Access Compliance Report Public Rights-of-Way (Curb Ramps)

Main Street: TUBEROSE_ST Cross Street: DUSKYWING_CT Location: NE

ADA ID: RPAT211029125929 Ramp Type: Type 4 - Parallel Initial Pass/Fail: Fail Overall Compliance: No Severity Score: 16

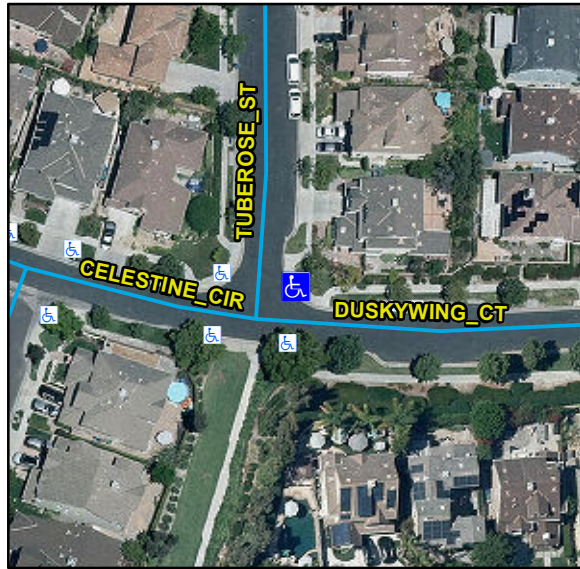
R204.3, R304.3.2, R304.5.3, STD 1115

Compliance	Description	Data	Compliance	Description	Data
N/A	Ramp Length LT (in)	100	N/A	Ramp Length RT (in)	93
Yes	Ramp Width LT (in)	54	Yes	Ramp Width RT (in)	54
Yes	Ramp Run Slope LT (%)	0.3	No	Ramp Run Slope RT (%)	10.5
Yes	Ramp Cross Slope LT (%)	1.2	No	Ramp Cross Slope RT (%)	3.2
N/A	Landing Present	N/A	N/A	DWS Provided	N/A
N/A	Landing Length (in)	N/A	N/A	DWS Contrast	N/A
N/A	Landing Width (in)	N/A	N/A	DWS Length (in)	N/A
N/A	Landing Run Slope (%)	N/A	N/A	DWS Full Width	N/A
N/A	Landing Cross Slope (%)	N/A		DWS Offset Type	N/A
N/A	Landing Movement Obstructed?	N/A	N/A	DWS Offset Left (in)	N/A
	Landing Movement Type	N/A	N/A	DWS Offset Right (in)	N/A
N/A	Landing Shared	N/A			
N/A	Clear Space	Yes			
N/A	Clear Space To Crosswalk (in)	N/A			
N/A	Marked Crosswalk 1	No	N/A	Marked Crosswalk 2	No
	Crossing 1 Direction	W		Crossing 2 Direction	S
	Marked Crosswalk 1 Width (in)	N/A		Marked Crosswalk 2 Width (in)	N/A

Remove & Replace Curb Ramp With Two New Directional Ramps or Equivalent.
